NEWMAR CORPORATION WARRANTY DEPARTMENT

TECHNICAL SERVICE BULLETIN																			
DATE ISSUED		MODEL YEAR(S) AFFECTED			MODEL(S) AFFECTED			TSB #											
12/03/01		2001-2002			NewAire			234											
BRAND						TYPE													
All	<input type="checkbox"/>	American Star	<input type="checkbox"/>	Kountry Star	<input type="checkbox"/>	Dutch Star	<input type="checkbox"/>	All	<input type="checkbox"/>										
NewAire	<input checked="" type="checkbox"/>	Mountain Aire	<input type="checkbox"/>	Kountry Aire	<input type="checkbox"/>	London Aire	<input type="checkbox"/>	T T	<input type="checkbox"/>										
								F W	<input type="checkbox"/>										
								C A	<input type="checkbox"/>										
								D P	<input checked="" type="checkbox"/>										
								D B	<input type="checkbox"/>

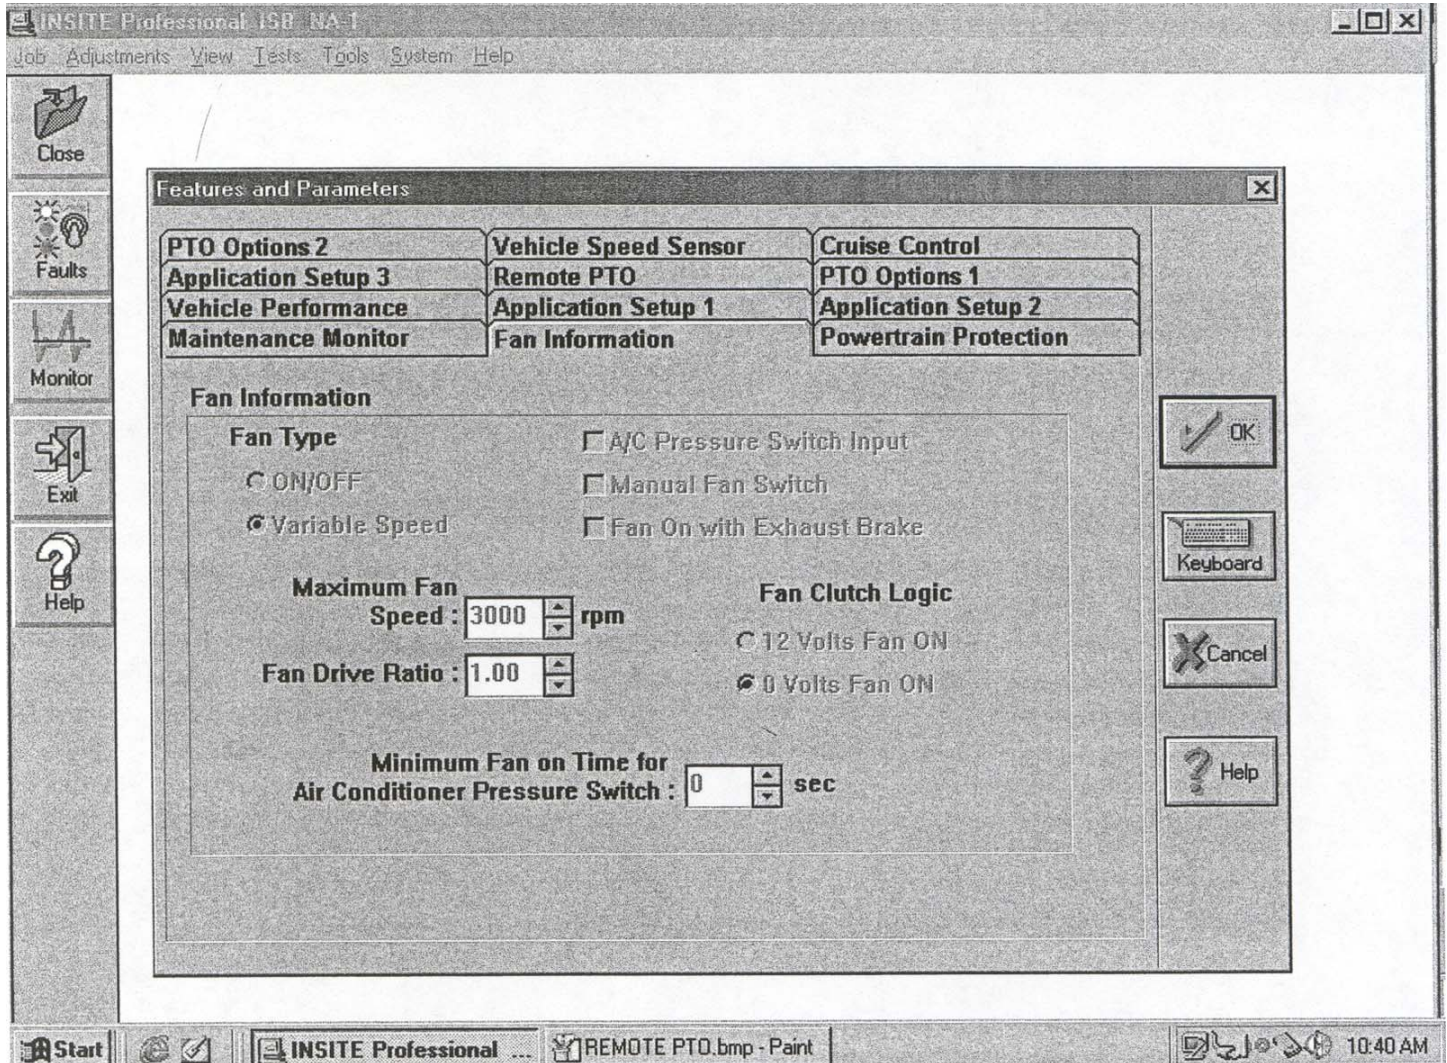
Maximum Speed in Top Gear : 90 mph

Maximum Speed without VSS : 3000 rpm

High Speed Governor Switched Speed : 3000 rpm

Top Gear : 0.74

One Gear Down : 1.00
